THE MICHAEL CARTER RESIDENCE
678 Primrose Lane, Friday Harbor. WA 98250

DAVID L. WALDRON / ARCHITECT
310 Spring Street P. O. Box 2505, Friday Harbor WA 98250
360 378 3070 davidlwaldronarchitect.com

MAIN FLOOR PLAN 1/8" = 1'-0" north

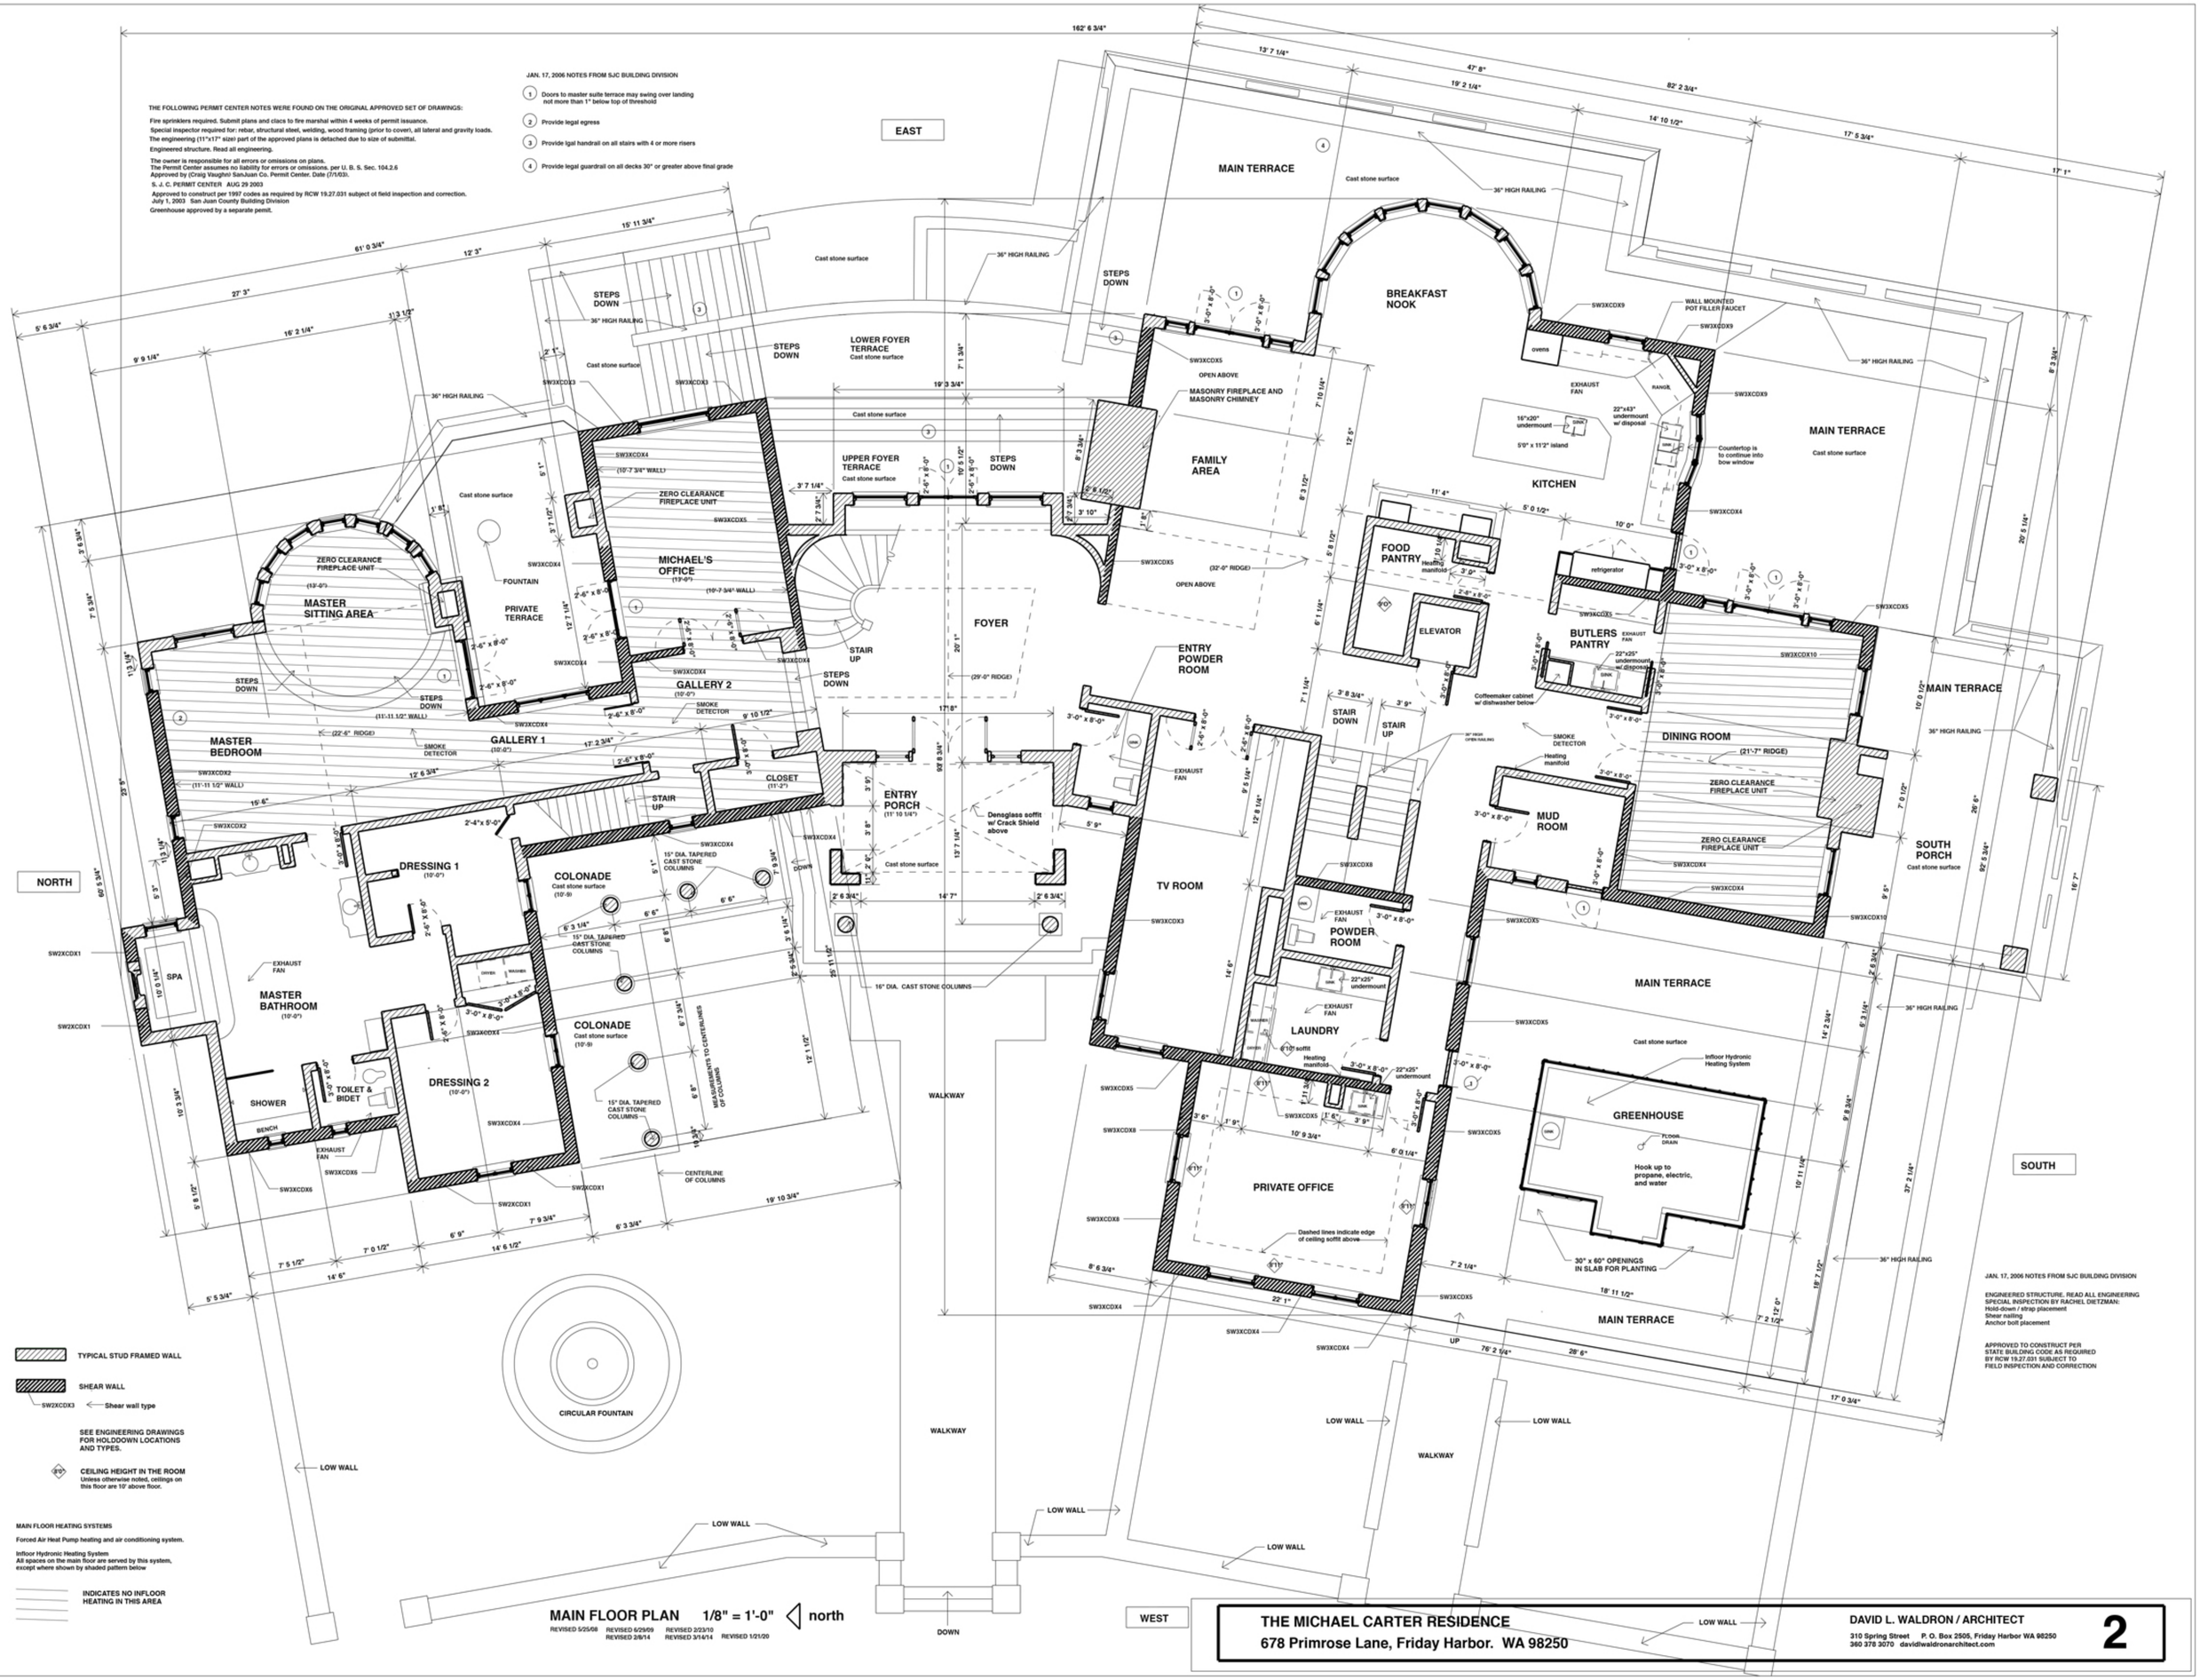
JAN. 17, 2006 NOTES FROM SJC BUILDING DIVISION

1. Doors to master suite terrace may swing over landing not more than 1" below top of threshold
2. Provide legal egress
3. Provide lgal handrail on all stairs with 4 or more risers
4. Provide legal guardrail on all decks 30" or greater above final grade

2ND FLOOR PLAN 1/8" = 1'-0" north

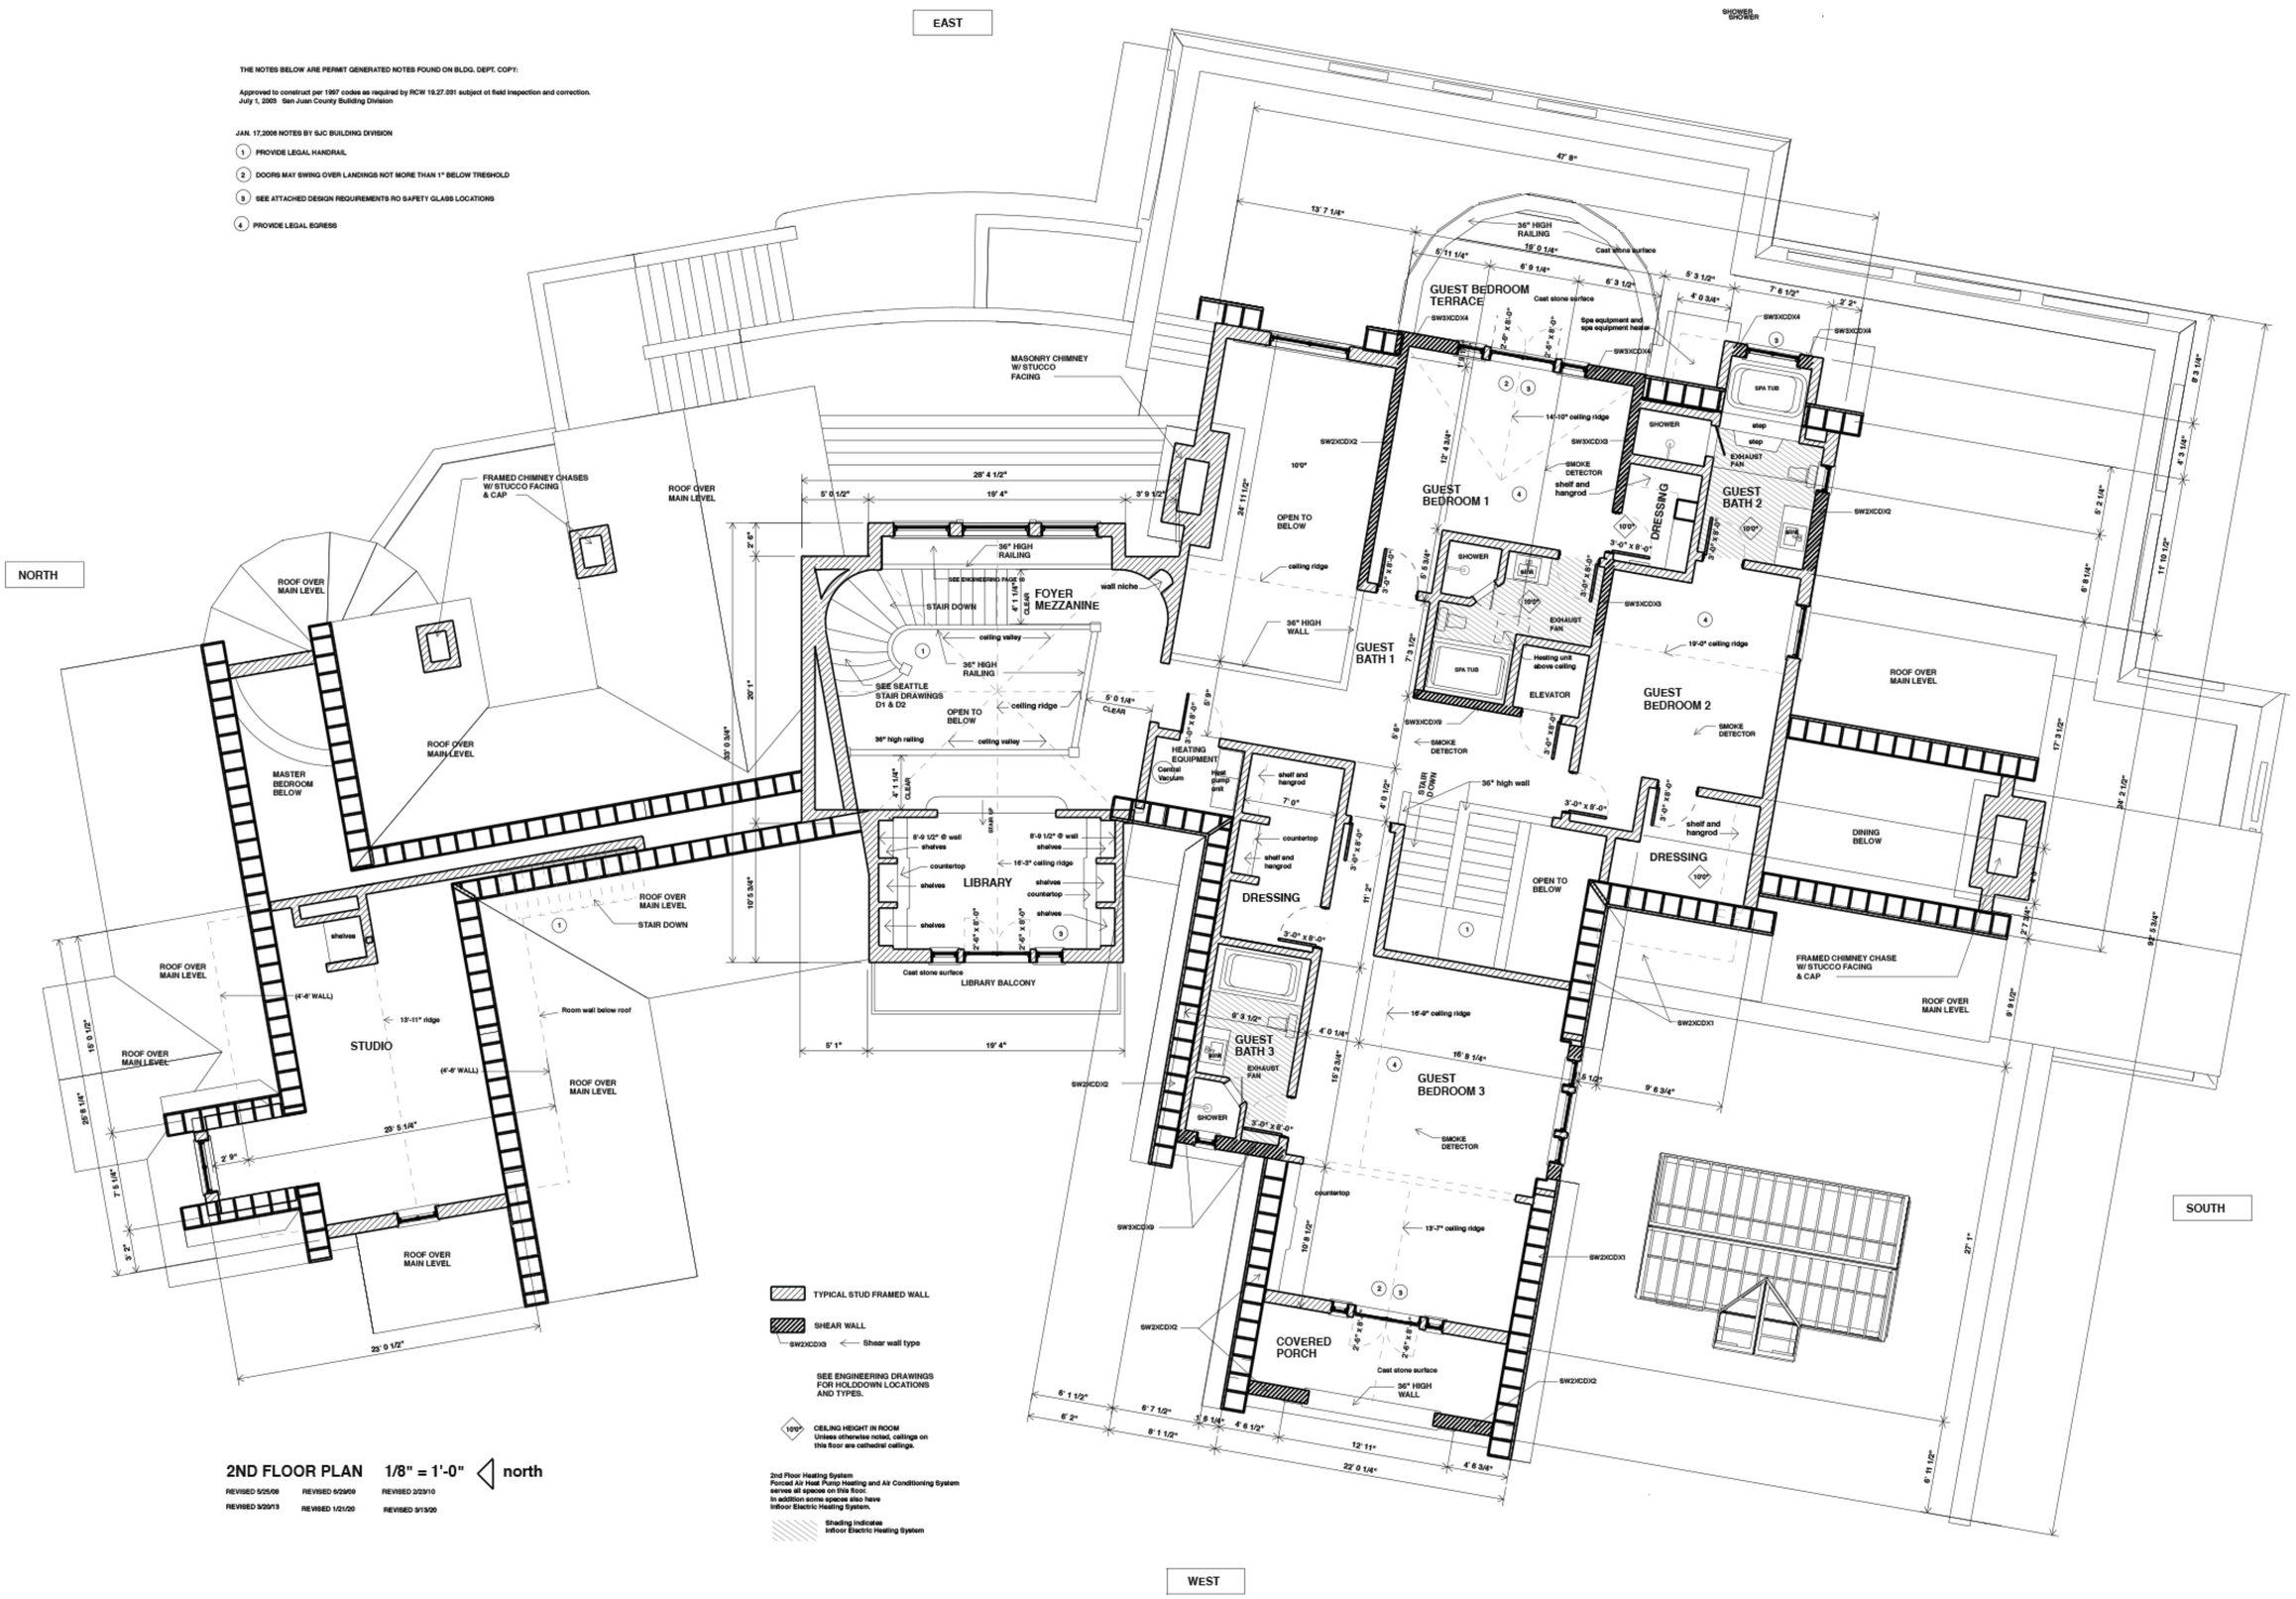
JAN. 17,2008 NOTES BY SJC BUILDING DIVISION

1. PROVIDE LEGAL HANDRAIL
2. DOORS MAY SWING OVER LANDINGS NOT MORE THAN 1" BELOW TRESHOLD
3. SEE ATTACHED DESIGN REQUIREMENTS RO SAFETY GLASS LOCATIONS
4. PROVIDE LEGAL EGRESS

GROUND FLOOR PLAN 1/8" = 1'-0" north

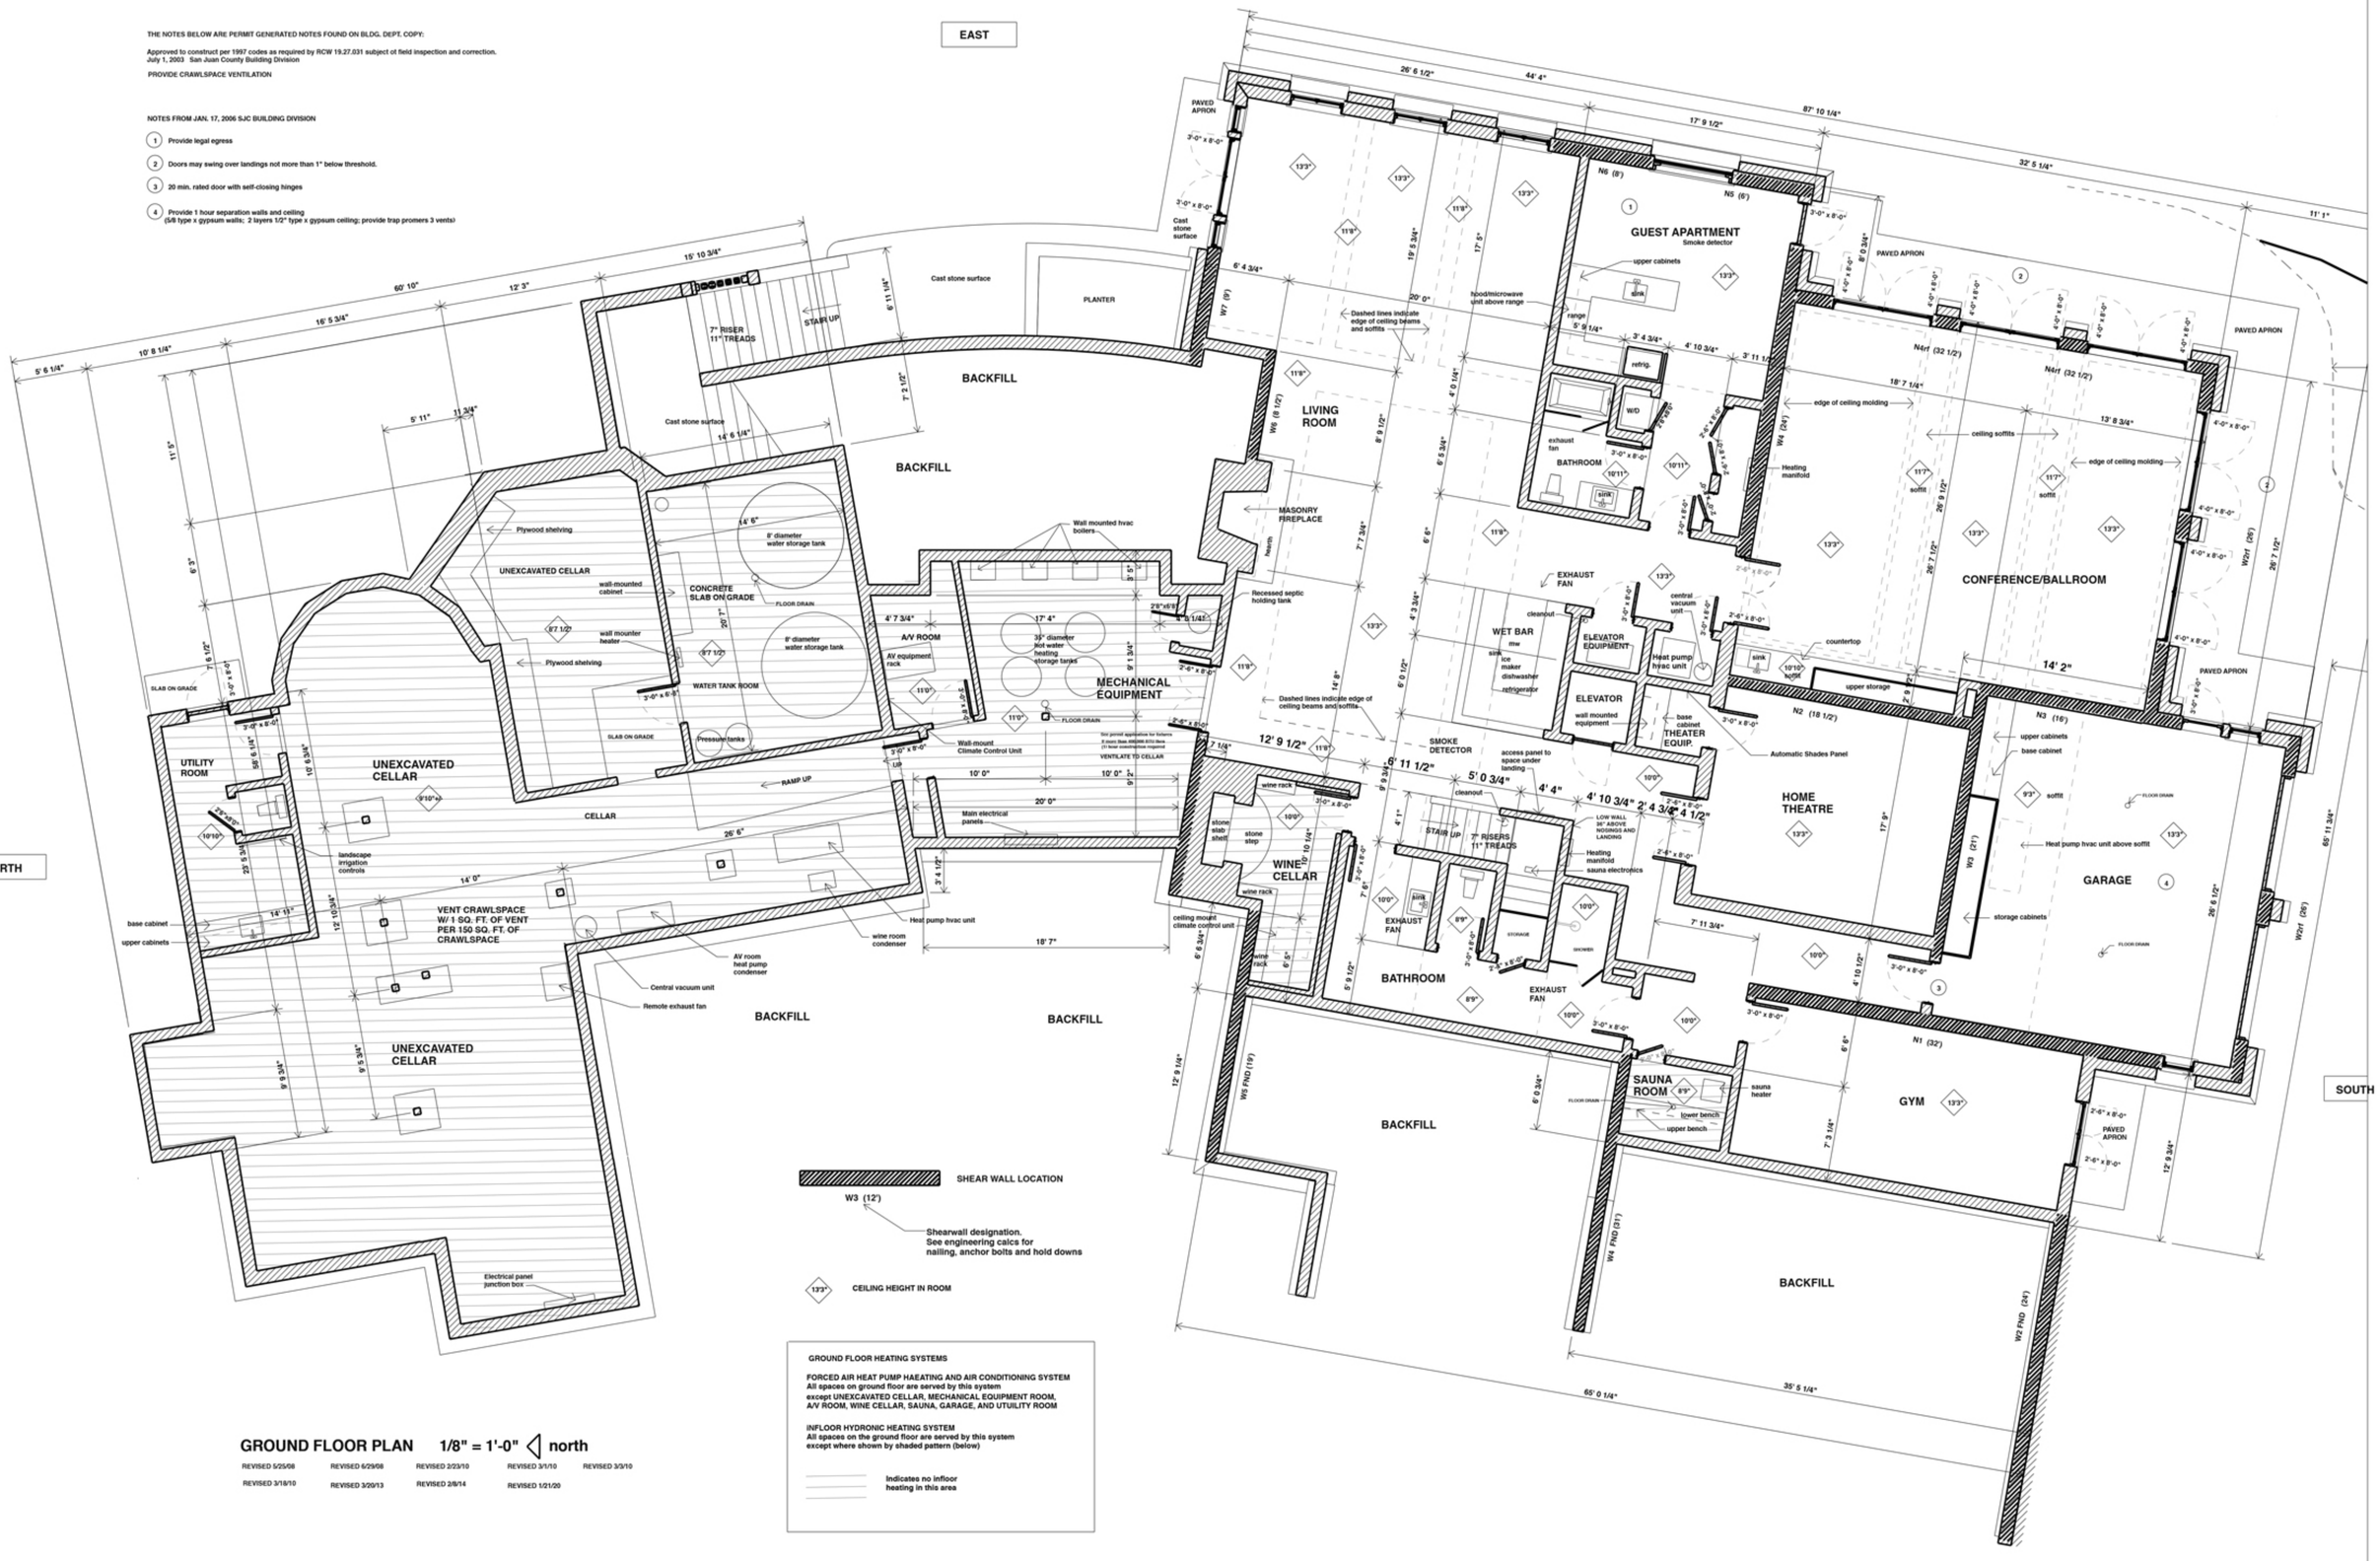
PROVIDE CRAWLSPACE VENTILATION

NOTES FROM JAN. 17, 2006 SJC BUILDING DIVISION

1. Provide legal egress
2. Doors may swing over landings not more than 1" below threshold.
3. 20 min. rated door with self-closing hinges
4. Provide 1 hour separation walls and ceiling (5/8 type x gypsum walls; 2 layers 1/2" type x gypsum ceiling; provide trap promers 3 vents)
